15 modules from THP 2/2016

#1, wide end

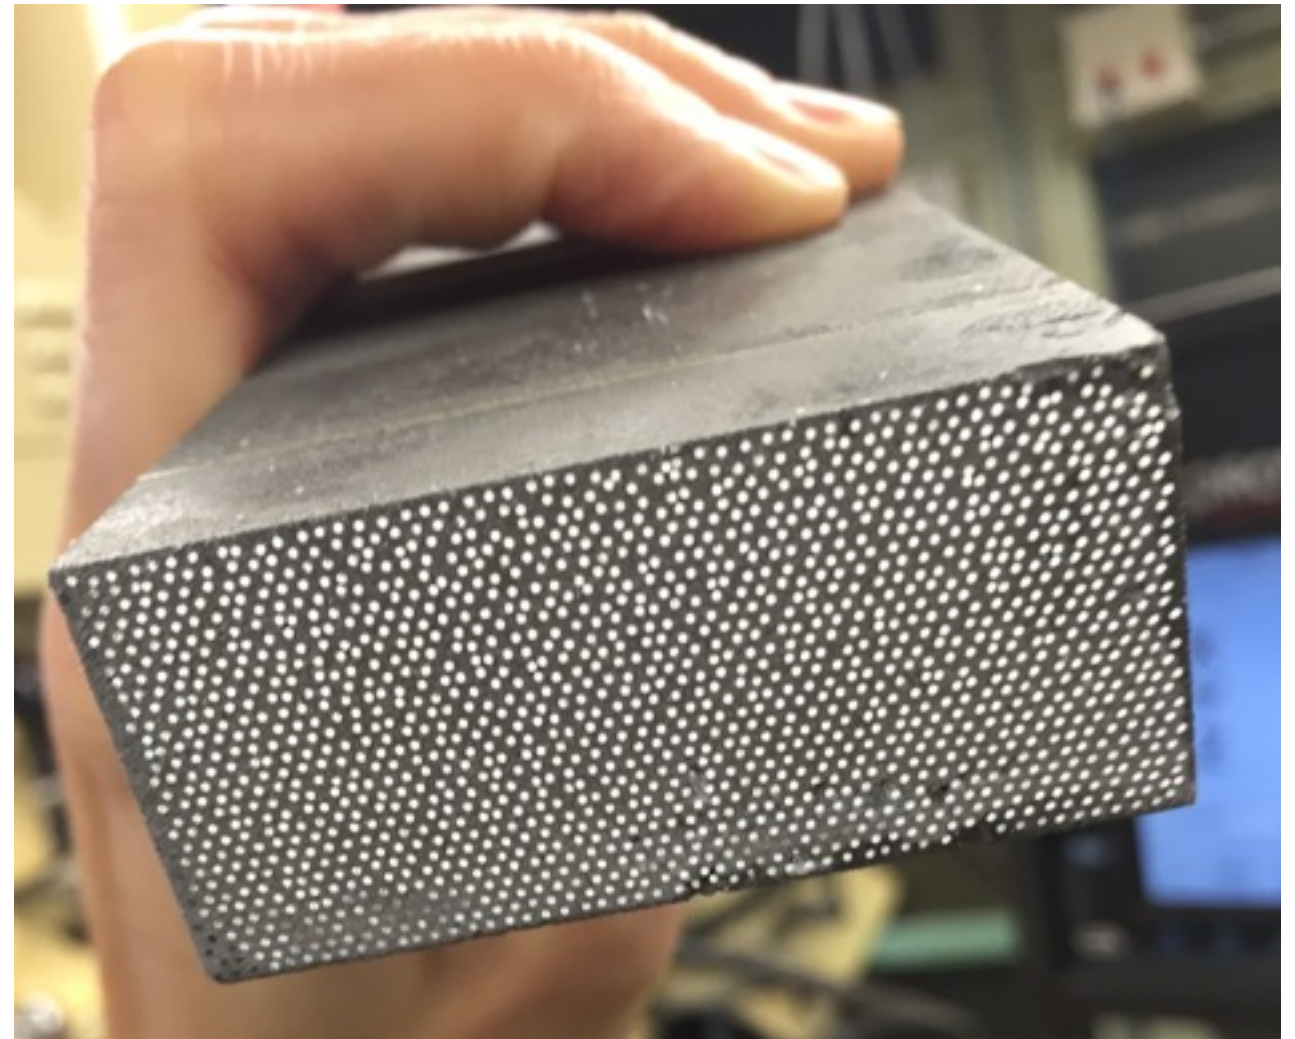
- no markings on the modules so we assigned them numbers 1-15
- 5 modules too short before cutting:
 - by ~ 10-20 thousandths
 - #8, 9, 10, 12, 14
- modules fly cut to get as good of ends as possible
 - length was treated as a secondary concern
 - none were left too long, but most ended up short of the spec
 - machined down to expose buried fibers on the narrow side (especially module #9, which was already short)
 - attempted to machine away voids on the narrow side, not always successful and in some cases machining created voids (epoxy issue?)—in those cases machining stopped

broken corners

#2

#13, narrow end

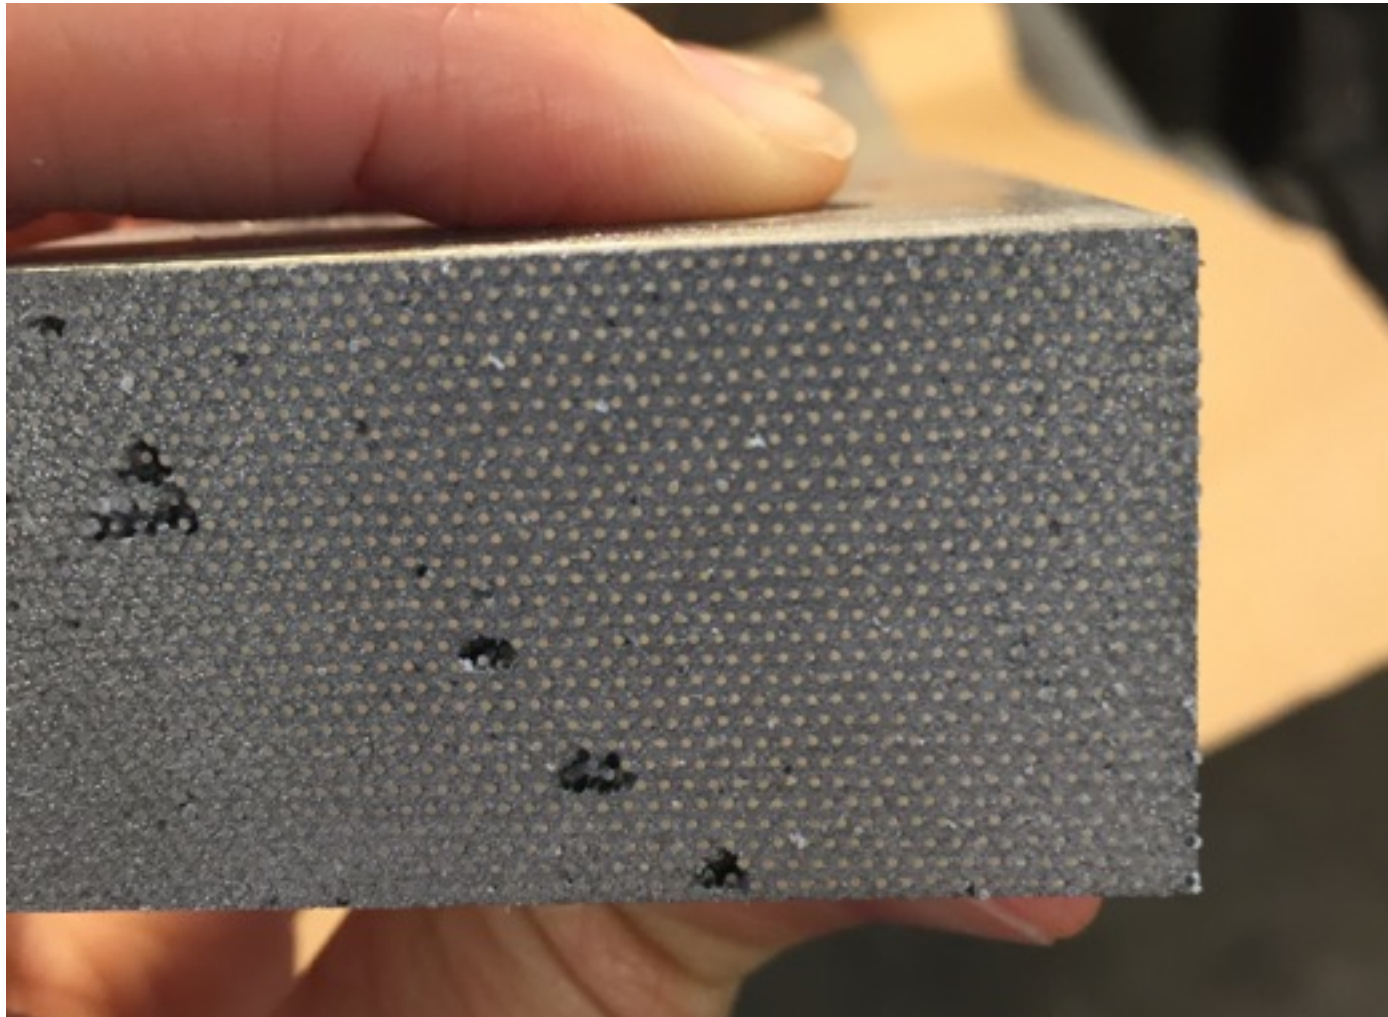
similar voids on #1, 15, 4 on
wide end
#3, 13 on narrow end

fiber issue module #15

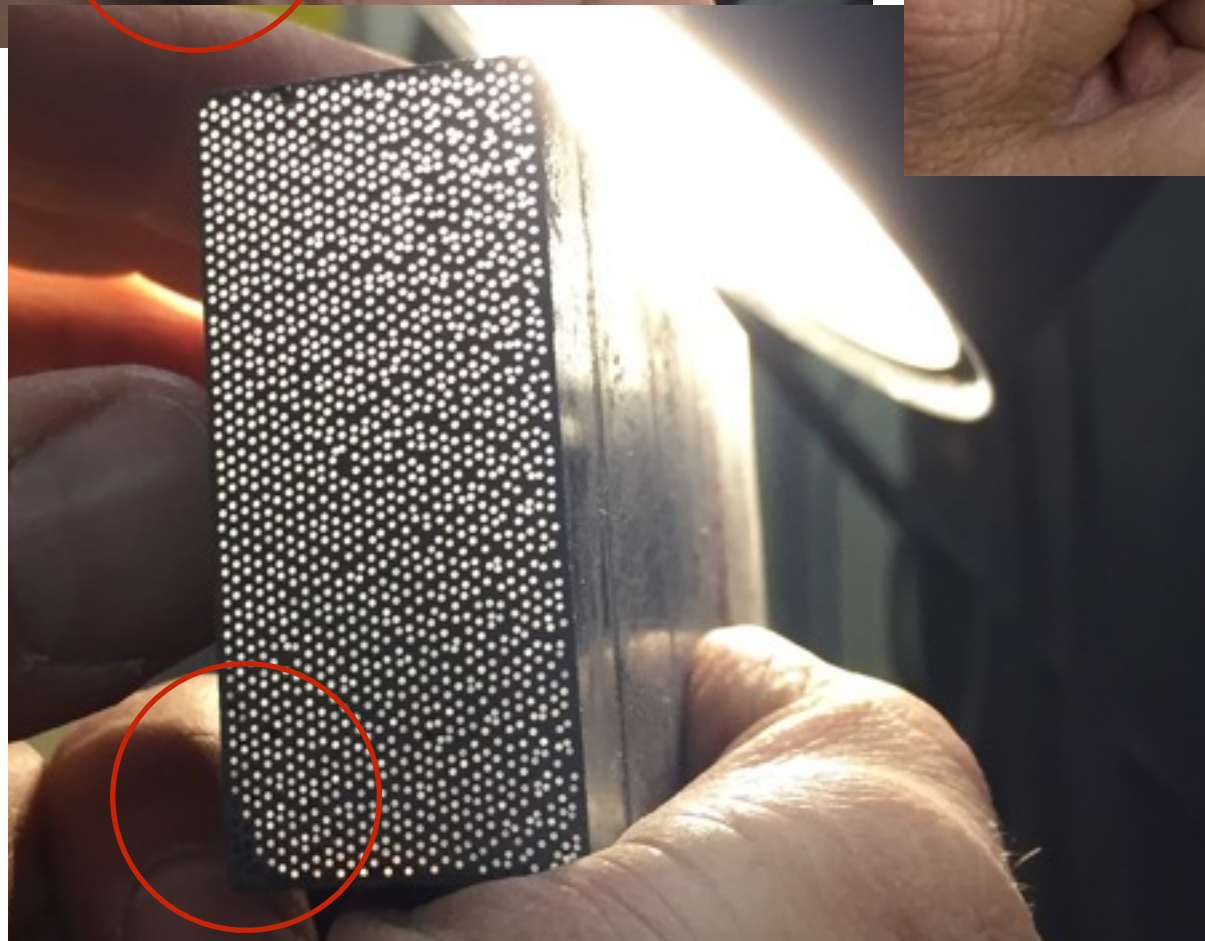
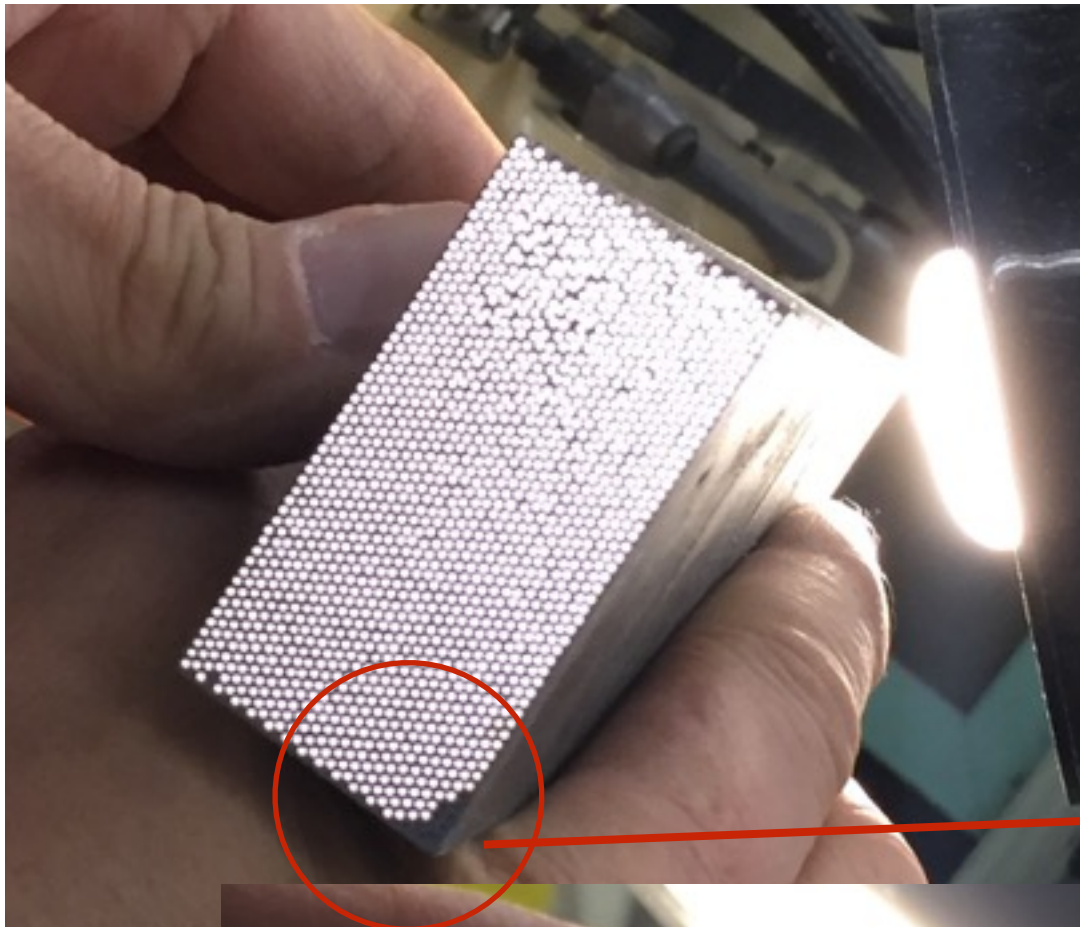
corner fibers exposed
on both ends, no
obvious damage on
outside of module
